UNITED STATES PATENT AND TRADEMARK OFFICE

10/820,955

Office Action Summary	Application No. 10/820,955	Applicant(s) BERG ET AL.	
	Examiner Monique M. Wills	Art Unit 1795

DETAILED ACTION

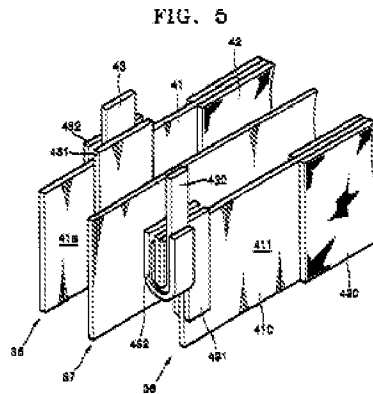
With respect to claims 1 & 11, Kim teaches an energy storage device comprising: a casing (1) having an opening; an electrode assembly (32) disposed within the case, wherein the assembly includes a first polarity electrode mechanically connected to a first electrode tab, and a second polarity electrode member electrically and mechanically connected to a second electrode tab. See Figure 5.

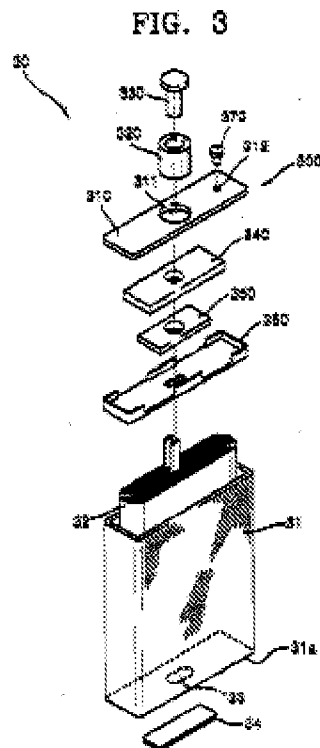
Further concerning claims 1, 11 & 13, the cover (310) is disposed to cover the opening of the case, wherein the cover defines a hole; and a terminal structure (380) attached to the cover, including: a gasket (320) made of insulating material and fittingly dispose within the hole, and a fastening device (330) with a shaft passing through the gasket and the hole in the insulator member, wherein the fastening device applies pressure in the axial direction of the hole in the cover to press the gasket, the cover and electrode tab, the electrode insulator and second tab against each other to form a seal, and the fastening device is electrically insulated from the cover. See Figure 3.

With respect to claims 2 & 12, the case is electrically connected to the first electrode member to form a terminal and the fastening device is electrically connected to the second electrode member and forms another terminal of the energy storage device. See paragraph 42. With respect to claim 5, the hole has a counter bore. See Figure 3.
